**De Zavala Elevated Storage Tank Project
Solicitation Number: CO-00409-FG
Job No.: 15-6001**

**ADDENDUM 2
August 18, 2021**

REF. NO. EST-04R ▲
 SHEET 16R OF 65

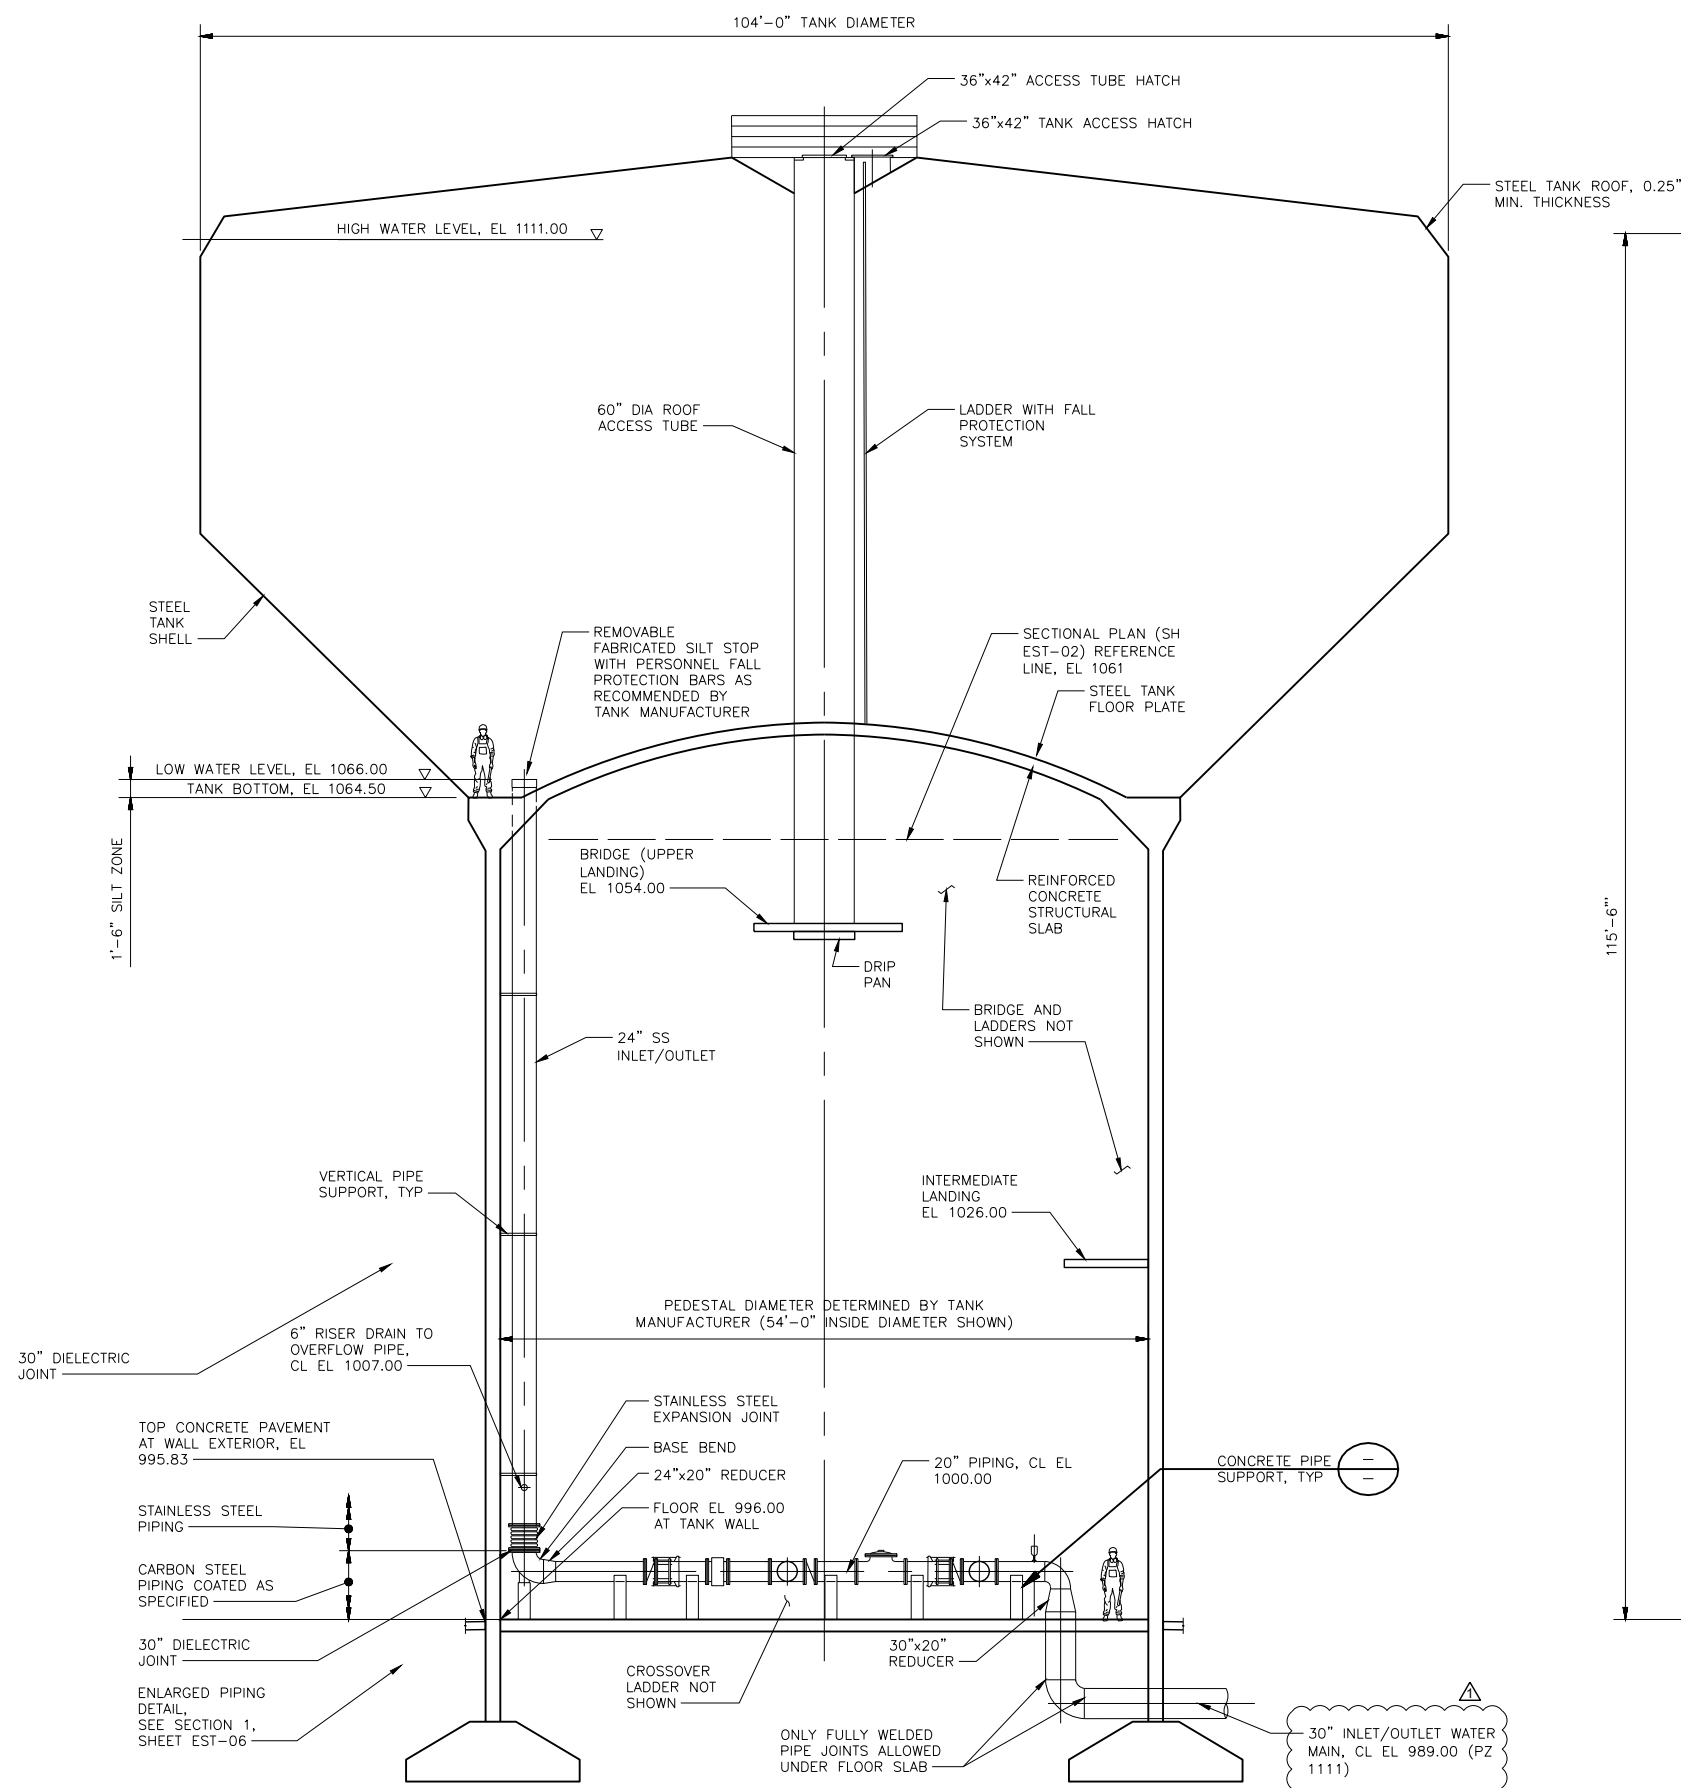
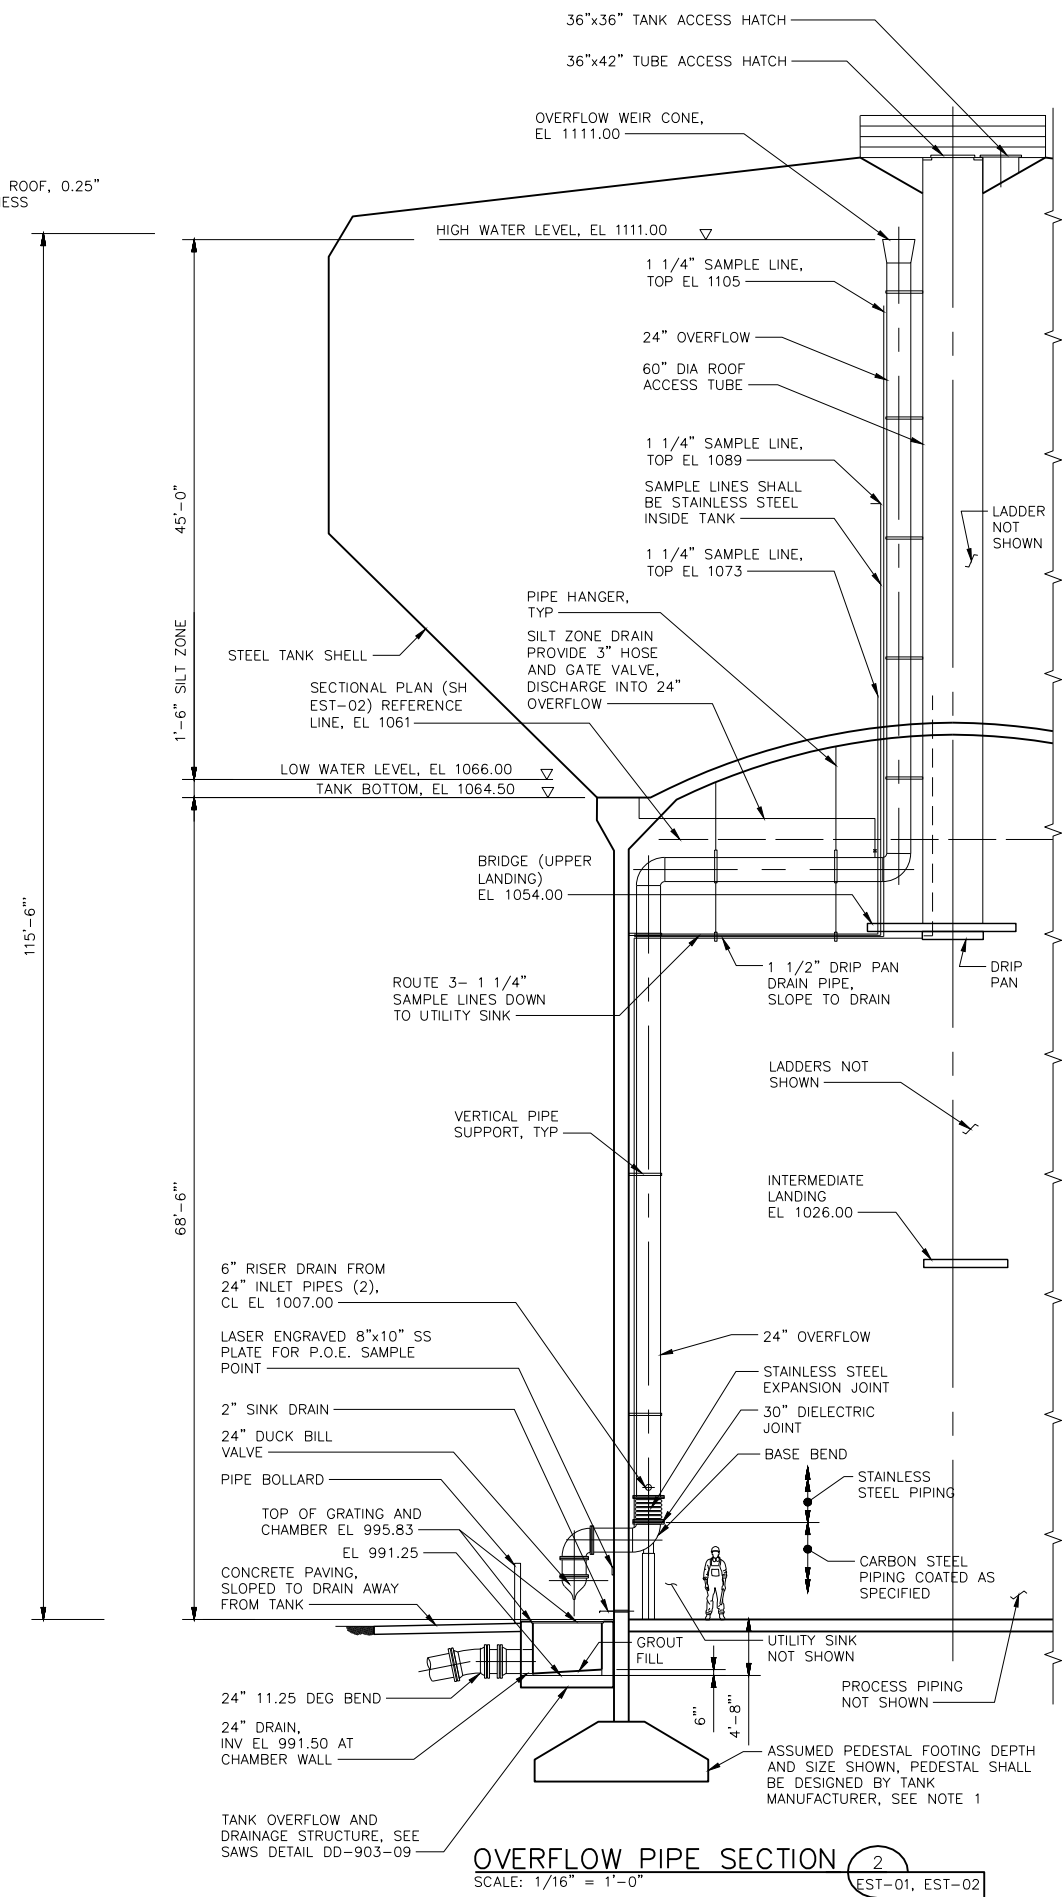
19. Question: There is a discrepancy as to the inlet, outlet, overflow and drain pipe material. The specs state SS and the dwg states steel. Please clarify if it is SS or CS. 33 06 05 par 2.01, 33 16 11 pg 10 par 2.06 L, dwgs EST-04,EST-05, EST-06 Mechanical note 1

32. Question: Please confirm the CL Elevation of the incoming waterline. Sheet 16 shows 991.67, Sheet 17 shows 989.00.

Response: *All above grade pipe material for the inlet, outlet, overflow and drain pipe materials shall be stainless steel extending up pedestal to tank from expansion joint/boot. Materials below expansion joint shall be carbon steel as specified. See SAWS Standard Detail DD-903-08 for reference and revised Design Drawings (C-04R, EST-05R & EST-06R). Refer to "Changes to Plans" (Design Drawing EST-04, EST-05 & EST-06) section as included with this addendum.*

Response: *CL Elevation of 989.00 shall be used for the inlet/outlet water main. Refer to “Changes to Plans” section (EST-04, Sheet 17 of 65) as included in this addendum.*

REF. NO. EST-05R △
SHEET 17R OF 65

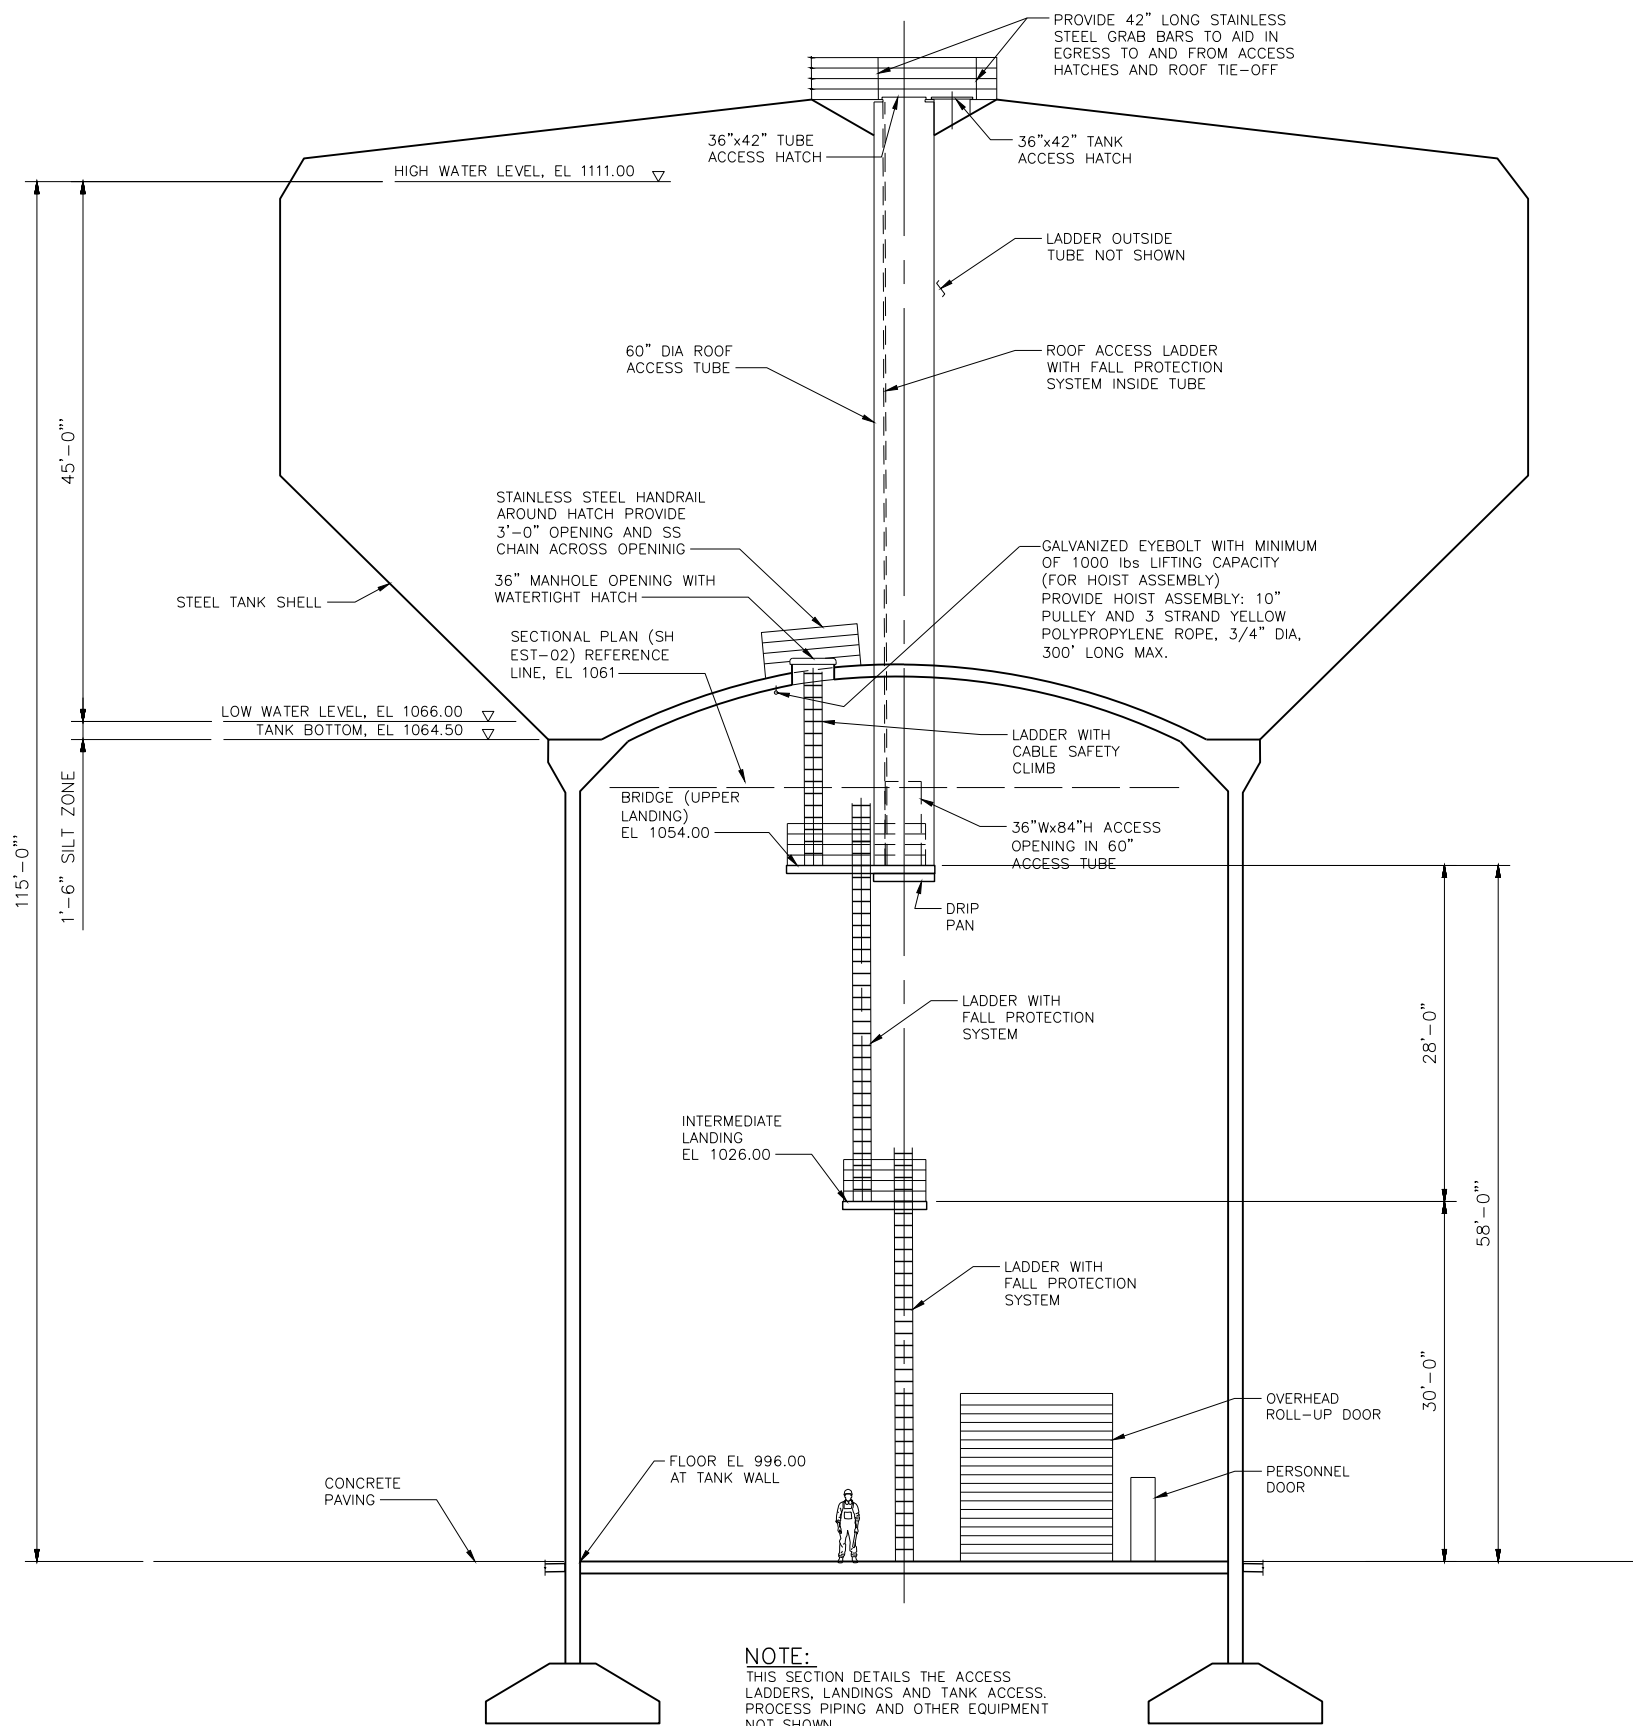
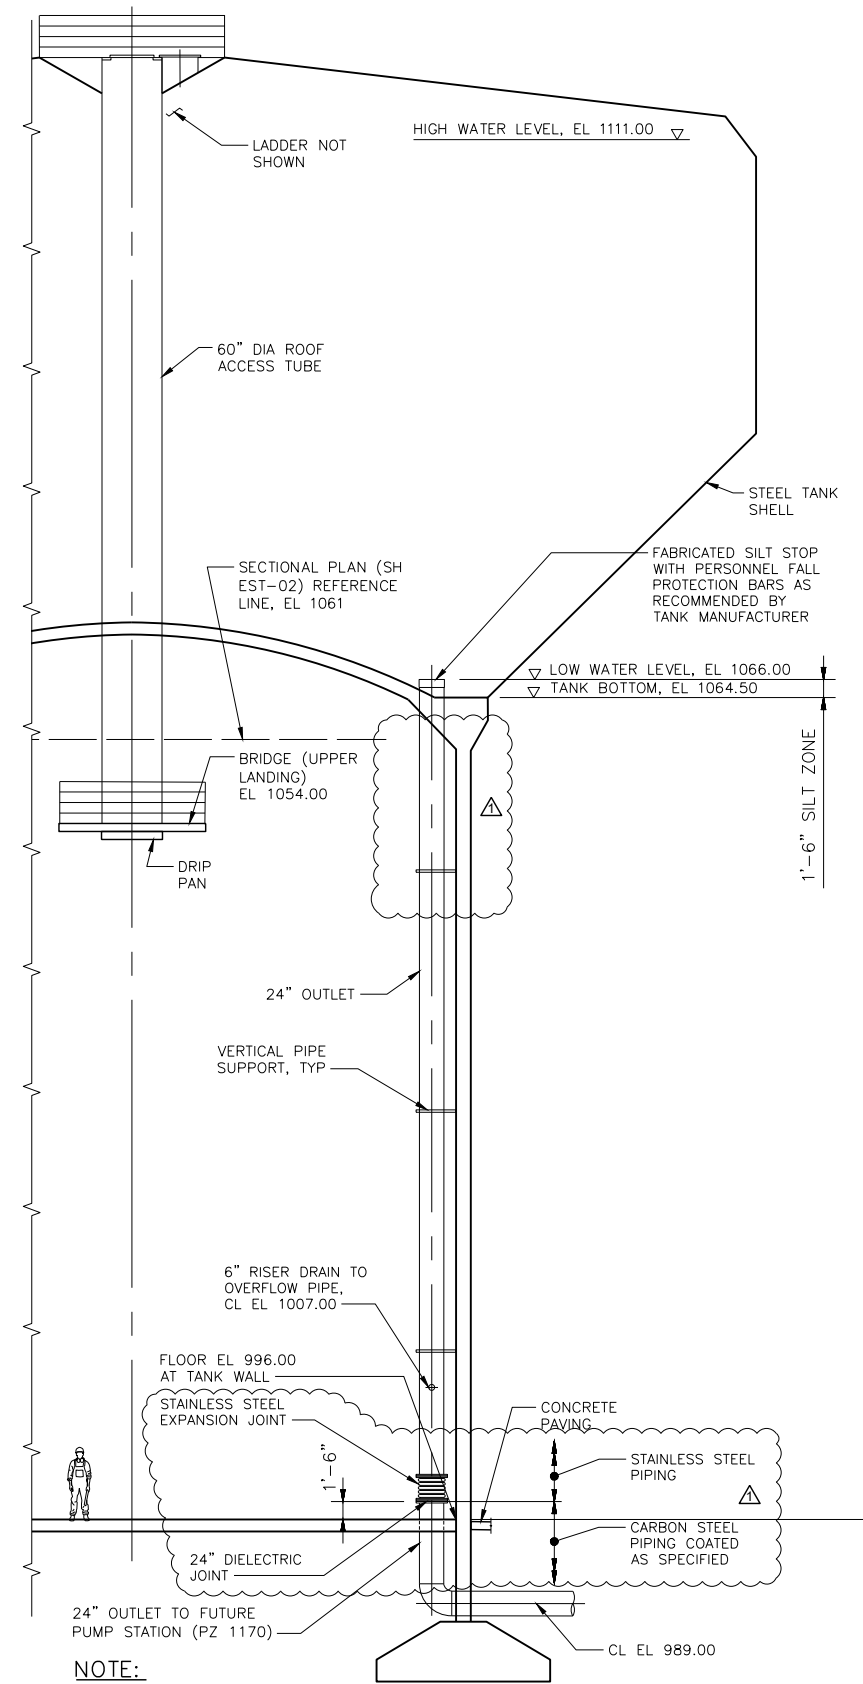
17. Question: There are discrepancies in the outlet pipe size and material. Dwg EST-05 show (PZ 1170) as 24"Ø CS with some type of coating. Spec section 33 06 05 par 2.01 C states (PZ 1170) as 30"Ø and 2.01 c 1 states 316 SS. Please clarify what is required for this pipe. Dwg EST-05, 33 06 05 par 2.01 C

- Response: *Contractor shall follow Floor Details as specified on Sheet EST-07.*
43. Question: Drawing 17 shows the pedestal interior ladder as being offset at the intermediate landings, Section 33 16 11 Item 2.06.B describe a straight run ladder system. Please clarify.

- Response: *PZ1170 Outlet shall be 24" diameter, 316 stainless steel pipe material for all above-grade piping within tank pedestal connected to a stainless steel expansion joint located approximately 18" above the tank slab. Remainder of PZ1170 Outlet (transition from expansion joint and below grade portion) shall be 24" diameter carbon steel in accordance with SAWS Standard Specifications. Refer to "Modification to Specifications" section 33 06 05-1 Item 2.01.C as included herein/below. Also refer to "Changes to Plans" (Design Drawing EST-05, Sheet 17 of 65) section as included with this addendum.*

- Response: *Ladder shall be offset in accordance with SAWS Standard Ladder Detail DD903-14 per prior response to Question #20.*
44. Question: Section 13 47 13 – Is Cathodic protection required for the 30" waterline? If so, can a specification be provided as the impressed current system within Section 13 47 13 is only applicable to the elevated tank.

1. Hach
 2. Approved Equal”
3. Amend Technical Specification 33 16 11-10 Item 2.06.J.1: REPLACE reference to 36”X42” vent opening with 24”x36”.
4. Amend Technical Specification 33 06 05-1 Item 2.01.C: REPLACE reference to “...30-inch Outlet Line (PZ 1170)...” WITH “...24-inch Outlet Line (PZ 1170)...”
